UNITED STATES PATENT AND TRADEMARK OFFICE

APPLICATION NO.	FILING DATE	FIRST NAMED INVENTOR	ATTORNEY DOCKET NO.	CONFIRMATION NO.
10/682,050	10/09/2003	Sidney E. Clark	03014/1086	8135

Office Action Summary

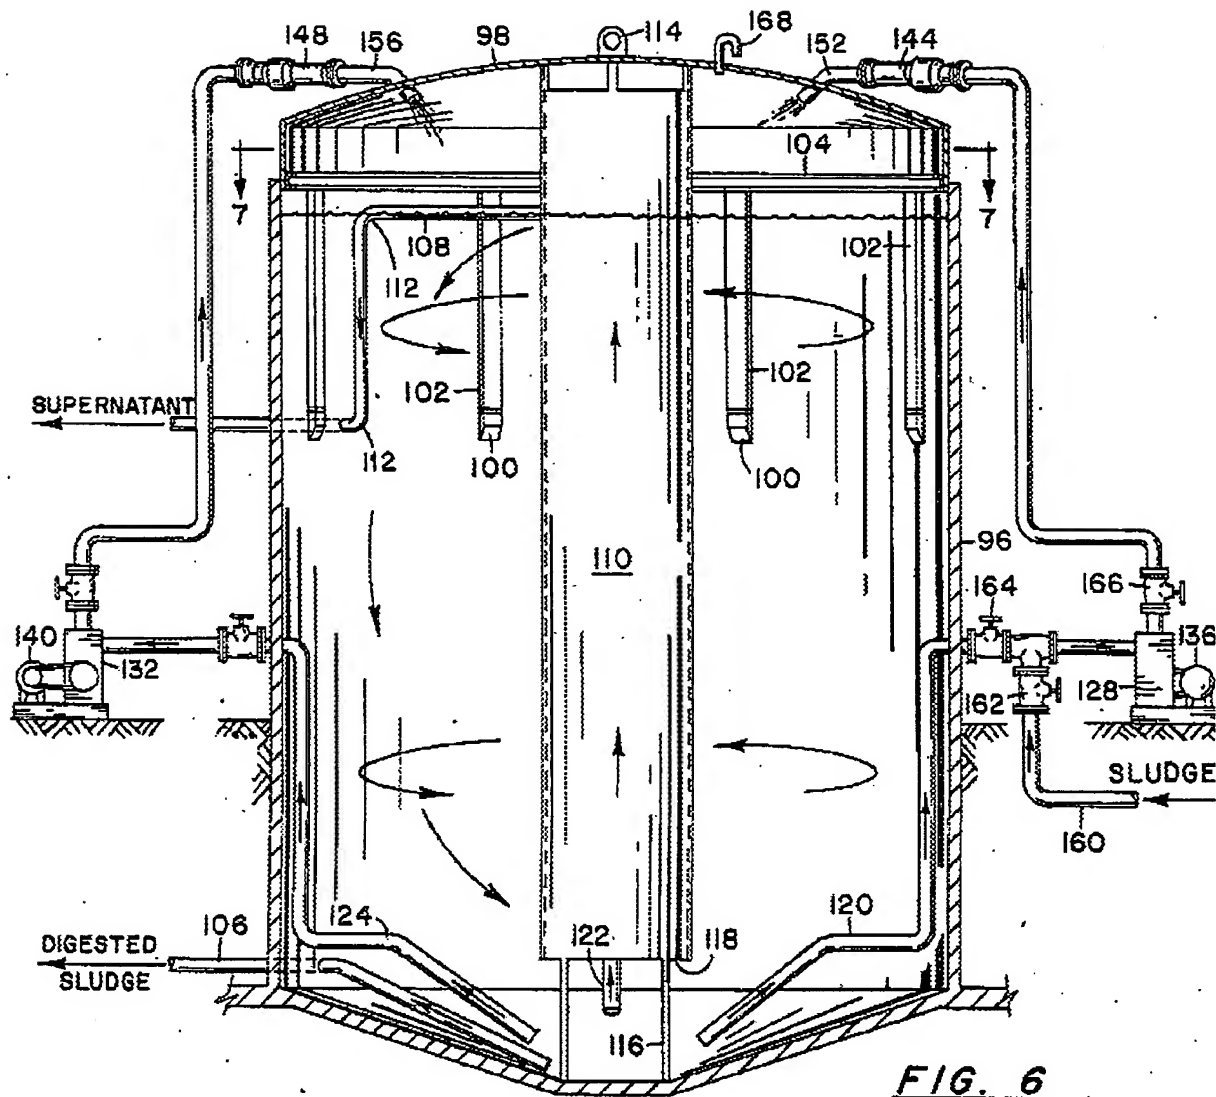
USP 3997437 to Prince describes an anaerobic sludge digester comprising a sloped bottom, a middle section, and a top section. There is a lower draft tube (124, for drawing material from the bottom of the vessel), an upper draft tube (156, for discharging material to the upper portion of the vessel), and a pump 132 for causing liquid to flow through both the upper draft tube and the lower draft tube. Per claim 14, material flows with a downward component through the upper draft tube (near where element 104 appears) and upward through the entrance to the other draft tube (near where element number 116 appears). Per claim 24, froth or foam is generated at the top because the liquid discharge from the upper draft tube is above the liquid surface in the vessel, thereby allowing air to be entrained below the liquid level thereby forming froth or foam.
